NOTICE OF ENVIRONMENTAL REVIEW PERIOD

APPLICATION NO.: 08-0050

Environmental Review Initial Study

Application Number: **08-0050**

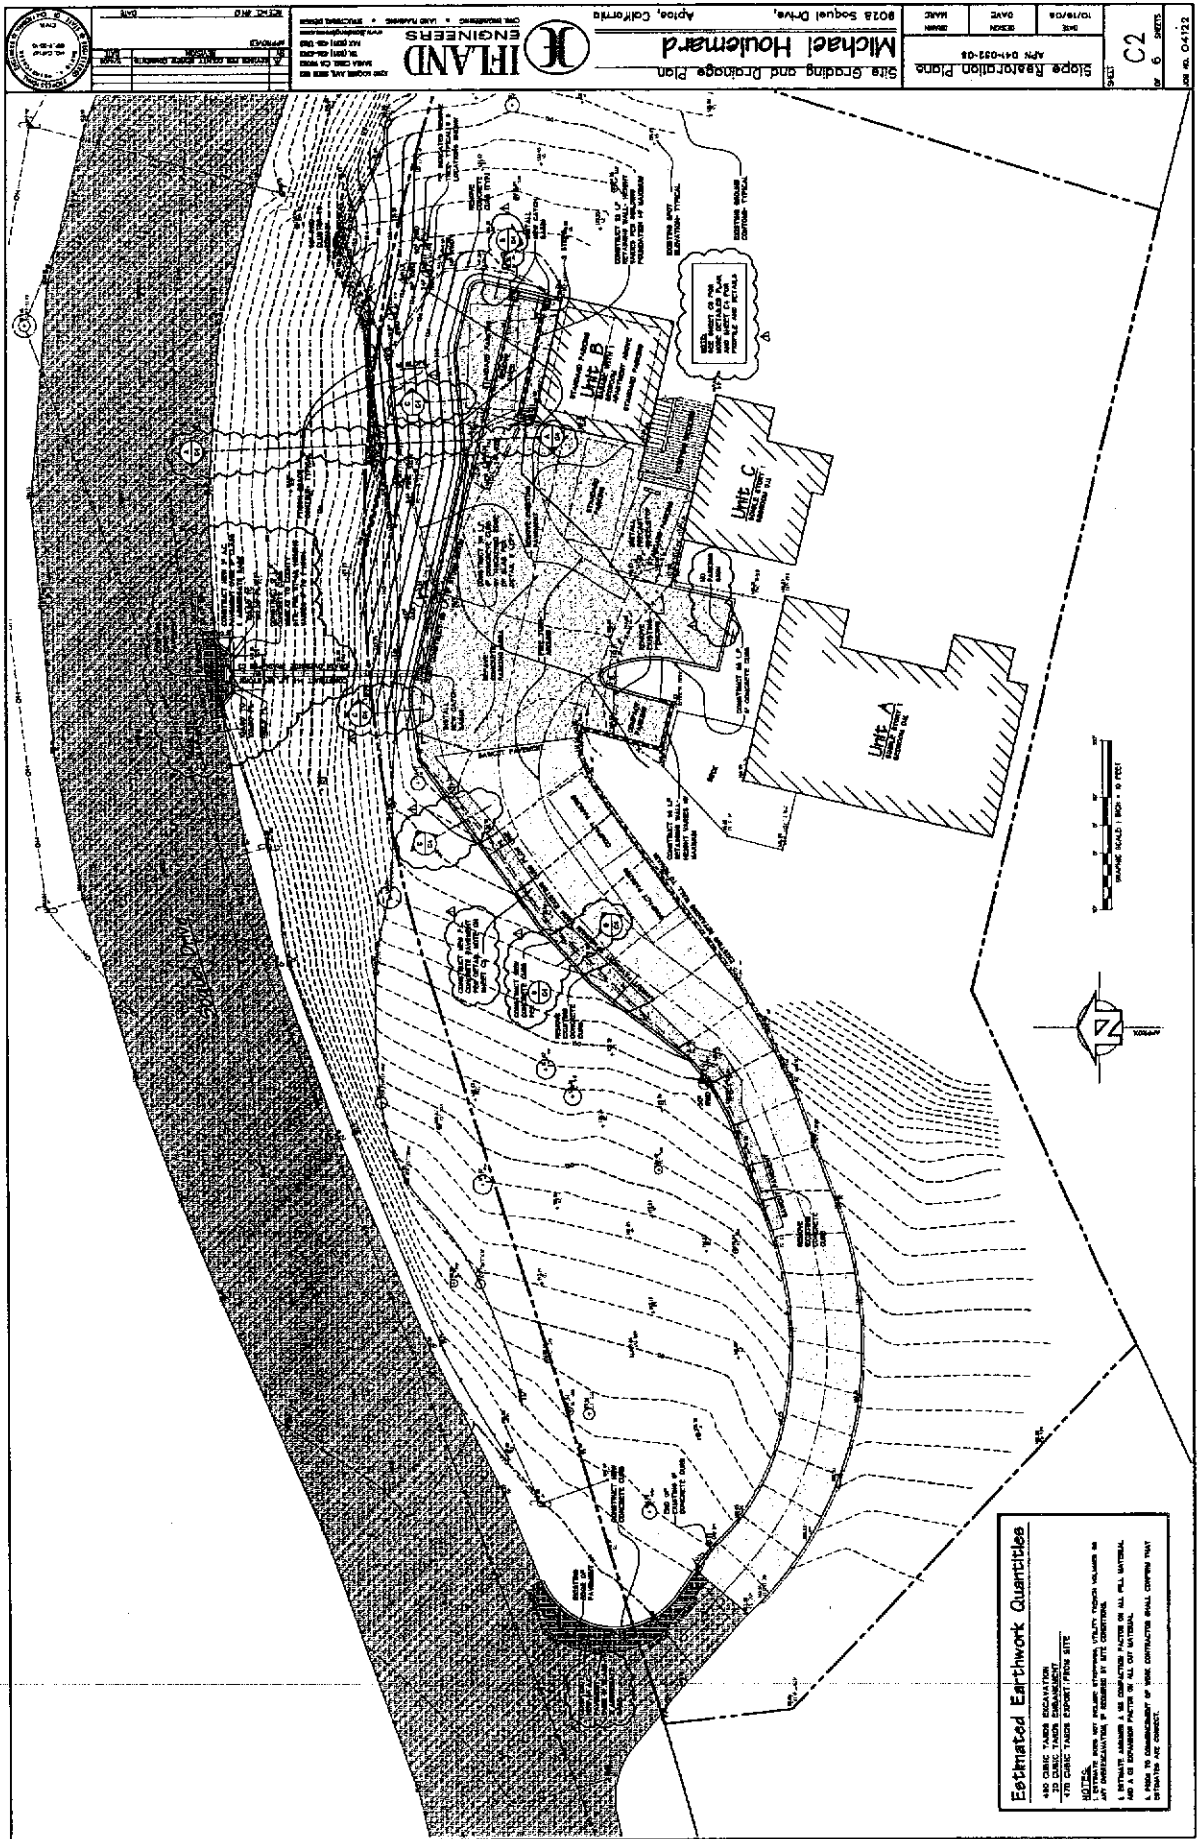
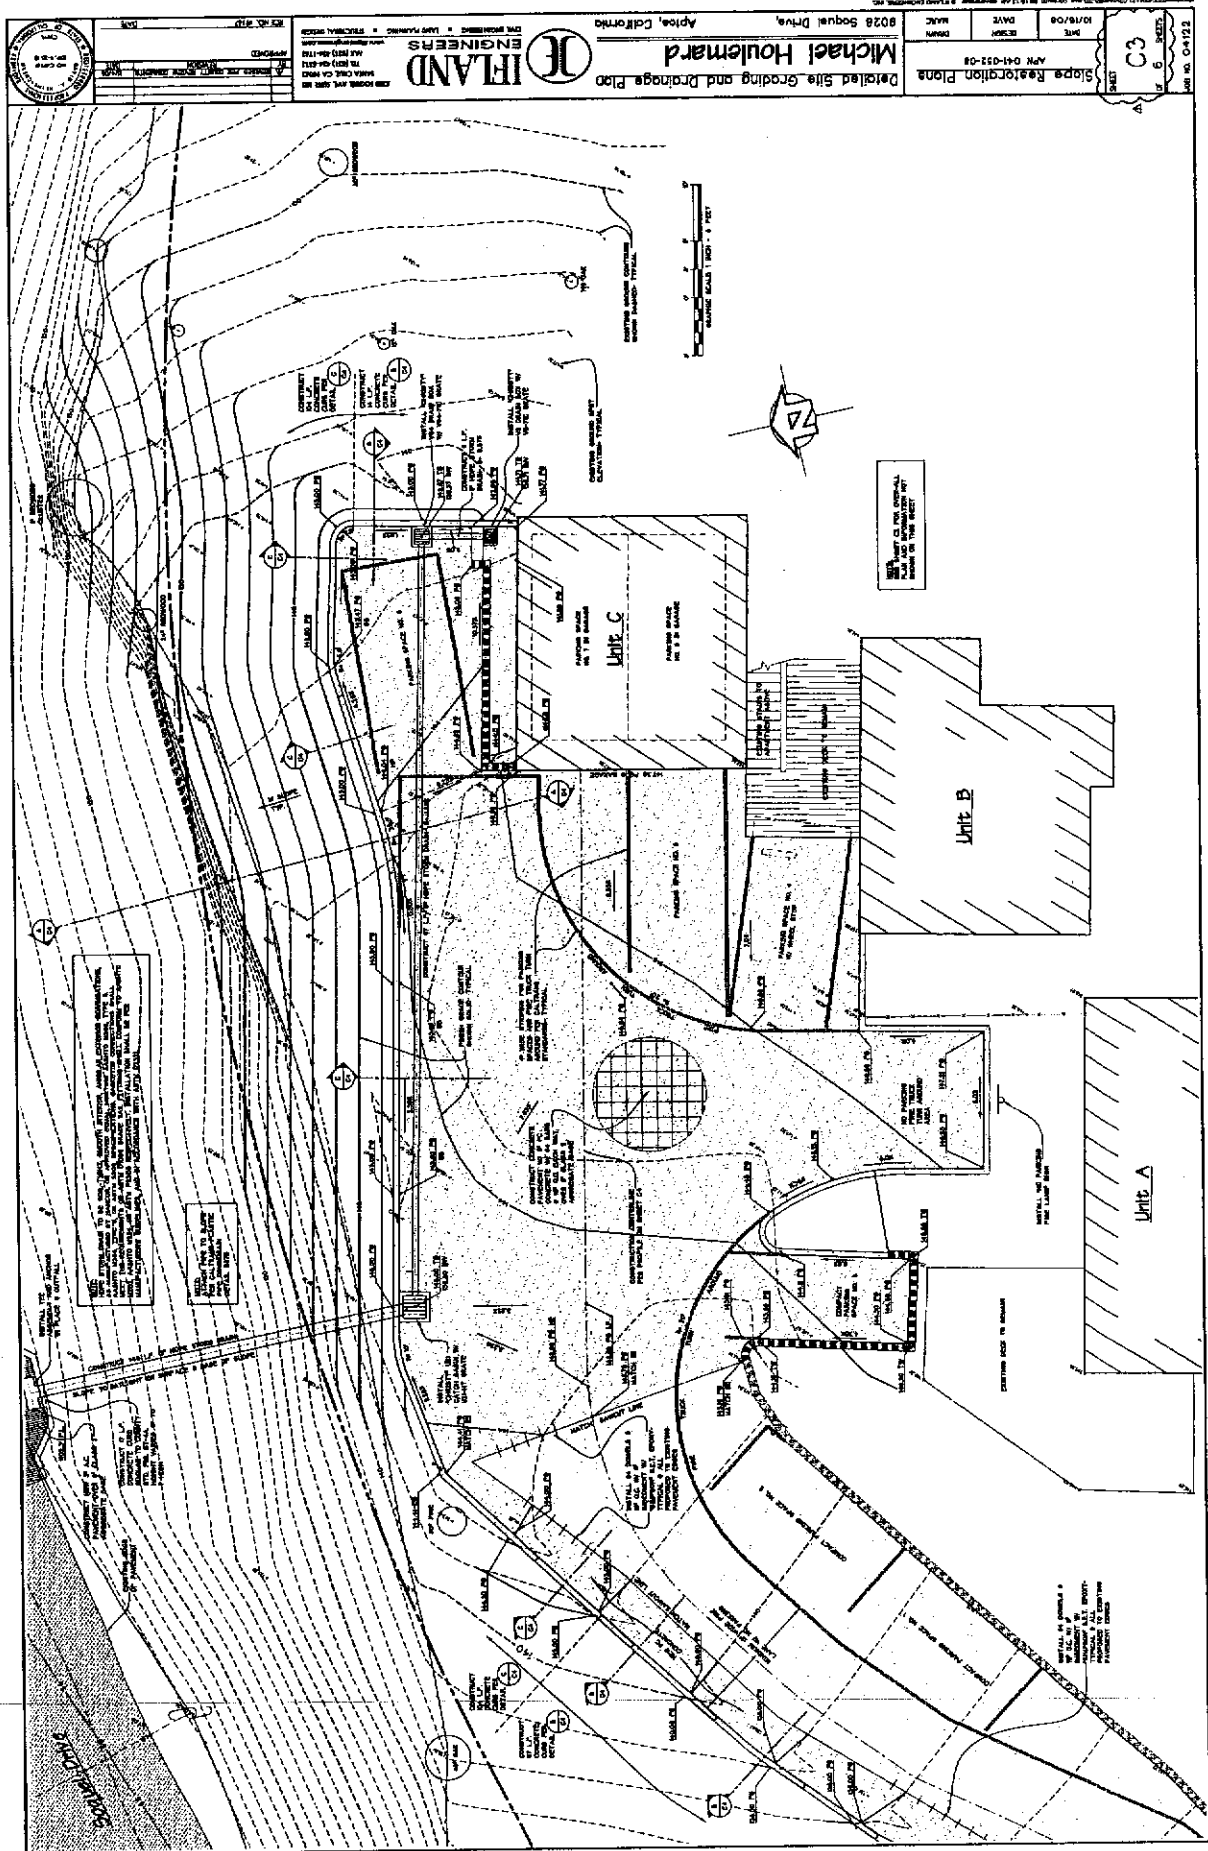
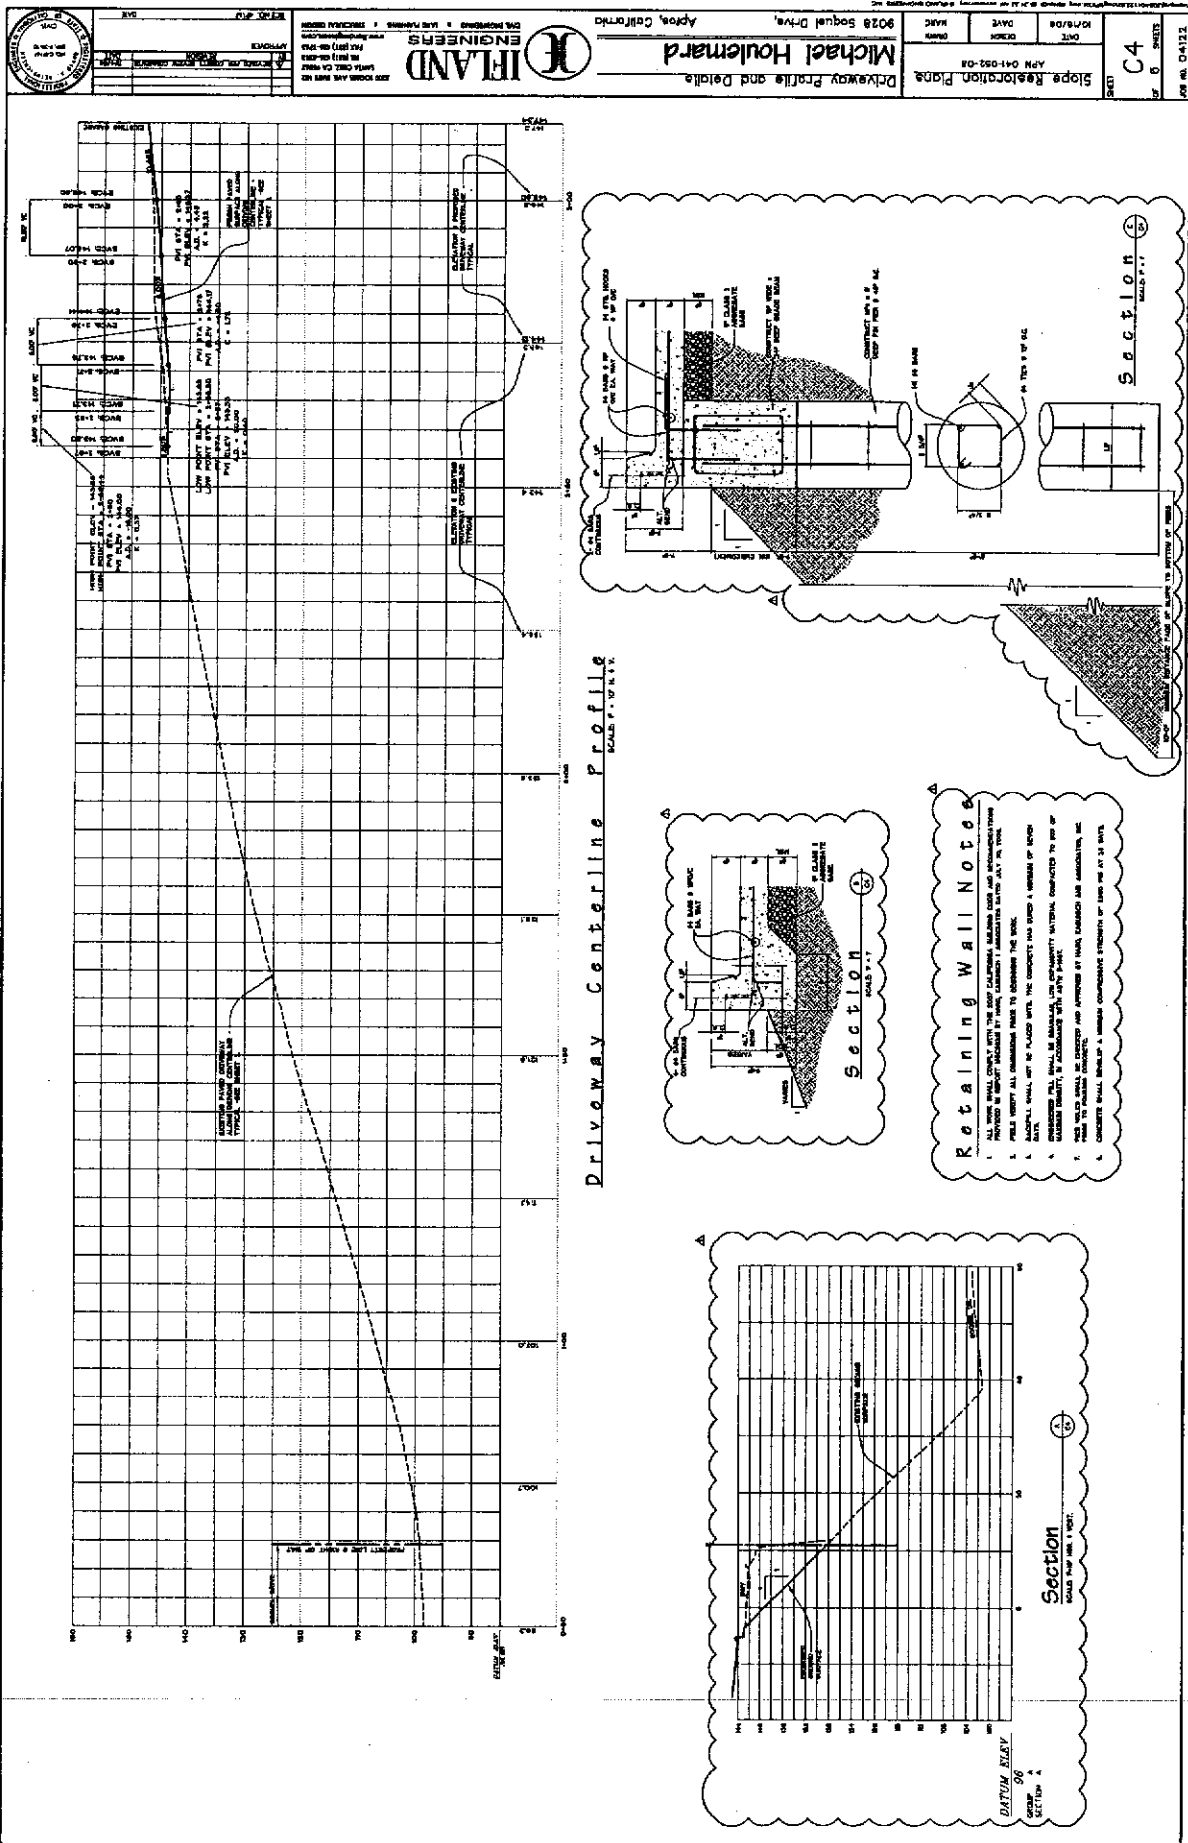
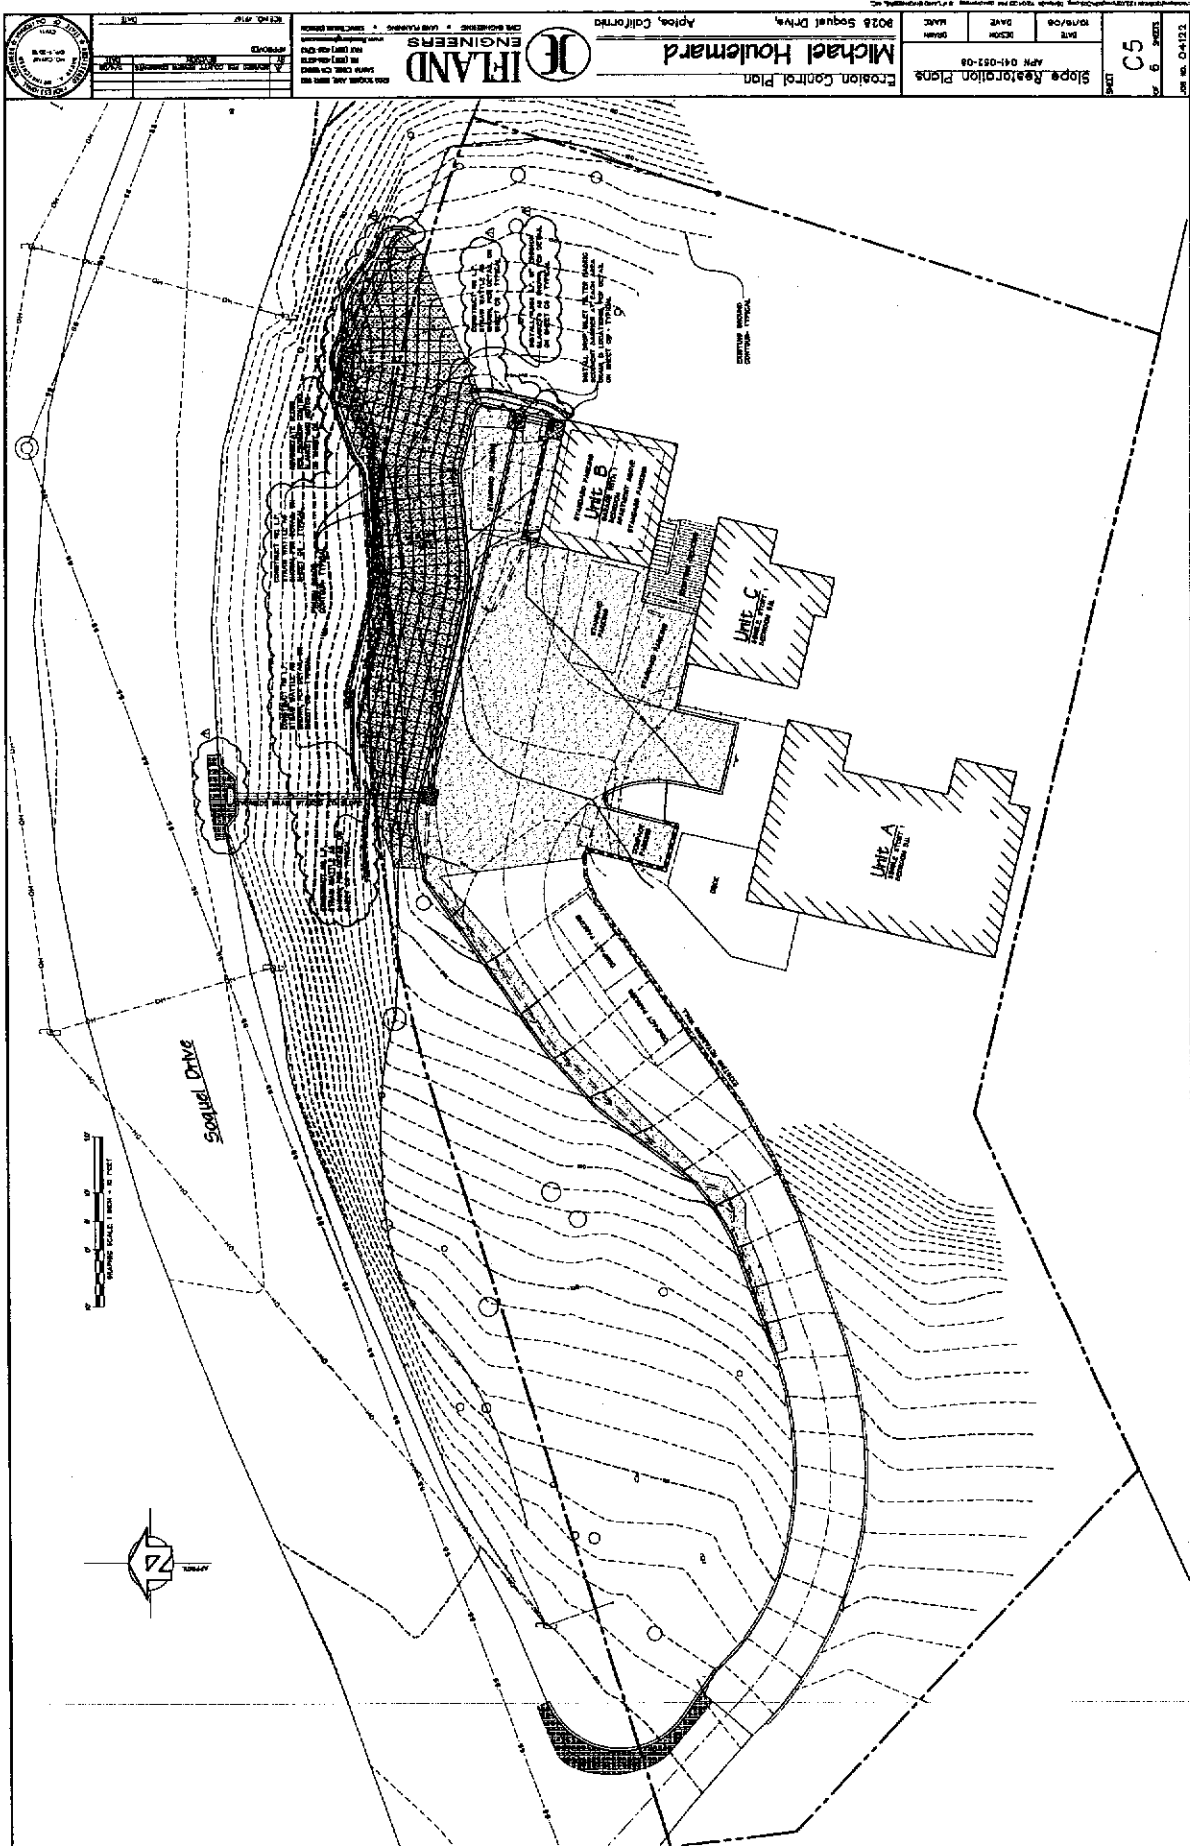
4. Evacuation of the soil beneath the proposed grade beam at the crest of the excavation is inevitable. What type of maintenance will be required to maintain the wall and driveway when erosion occurs beneath the grade beam? How does the design provide for access to this area?

5. The proposed final excavation will be almost 40-feet in height after regrading of the slope. Typically, a terrace drain is required mid-height by common practice and regional Codes to reduce the potential for shallow landsliding and erosion. The geotechnical report identifies erosion as a concern and makes recommendations for revegetation and erosion control plantings on the regraded portion of the slope. These appear appropriate. In addition to this erosion control, drainage and erosion control must be considered on the lower portion of the slope as well. The lower portion of the slope is already eroding and the proposed upper slope excavation, and will potentially increase the amount of drainage that will flow over the lower portion of the older excavation.

Please revise the grading plan to include project grading quantities in cubic yards of cut and fill. If overexcavation and recompaction are required by the soils report, these should be included as a separate grading line item.

Please revise the grading plan to label the top-of-wall and bottom-of-wall elevations for proposed retaining walls at beginning, end and transition points of the wall.

Please revise the grading plan to label pad elevations of the existing structures.

Show all trees proposed for removal, including those in the proposed new parking area. Include the diameter at breast height and the species for each tree to be removed and in the vicinity of the proposed work. ===== UPDATED ON SEPTEMBER 8, 2008 BY CAROLYN I BANTI =====

1. The proposed driveway does not meet current driveway standards with respect to geometry, grades, or structural section. The driveway shall be required to meet current standards. The applicant can either revise the plans or there may be a condition of approval that the driveway be modified to meet current driveway standards. A profile of the driveway should be provided which demonstrates the profile meets County standards.

3. On the building permit, all improvements in the County right-of-way are required to have construction notes. The revised plans should show both sides of the road and on either side of the driveway so that drainage can be evaluated. ===== UPDATED ON MARCH 10, 2008 BY GREG J MARTIN =====

In addition to our plan review, we provide the following responses to Comments 4 to 6 presented in a letter dated 2 September 2008, by Carolyn Banti and Joe Hanna of the Santa Cruz County Planning Department:

matting designed for severe slopes is low. We recommend the slope be monitored, especially during the first years, when vegetation on the slope is less well established. If erosion occurs, a bench should be constructed and soil replaced in lifts and compacted. The area can be accessed from the outer edge of the driveway, which will be supported with a pier and grade beam foundation.

5. The installation of a terrace drain is common on slopes of this height. However, the installation of a terrace drain would necessitate the loss of an additional 4 to 6 feet of the parking area (depending on the width of the terrace), further reducing the driveway/parking area, which has already been reduced by a width of 11 feet. The lower portion of the slope is thickly vegetated with grass, berry vines, and other groundcover. We do not recommend erosion mitigation measures on the lower portion of the slope because vegetation on the slope is occurring naturally. To install erosion control blankets on the lower slope, the existing vegetation should be removed and the slope groomed prior to installing the blankets. Since the increase in rainfall on the lower slope will be limited to incident rainfall which will fall on the graded slope we recommend that rather than lose the existing vegetative erosion protection, the lower slope should be monitored during the first few winters to evaluate if erosion control beyond the ongoing natural vegetation is necessary. If significant erosion occurs, removal of the vegetation, grooming of the slope and placement of erosion control blankets can be performed.

6. As we discussed in our report, the lower portion of the slope has accumulated soil which sloughed from the upper slope. The thickness of the accumulated soil is variable, and dependent upon the location. The steep upper slope has continued to spall off somewhat each rainy season, adding slightly more eroded soil to the lower slope. It is possible the soil may be thicker than a few feet in some locations. The planned grading and installation of erosion protection on the upper slope will prevent any additional eroded soil from accumulating on the lower portion of the slope in the future. However, the proposed grading will not eliminate the potential for sloughing of looser soil presently mantling the lower portion of the slope in the future, especially where the slopes are higher and/or steeper. However, if the lower portion of the slope remains well vegetated, the potential for erosion and shallow sloughing will be significantly reduced.
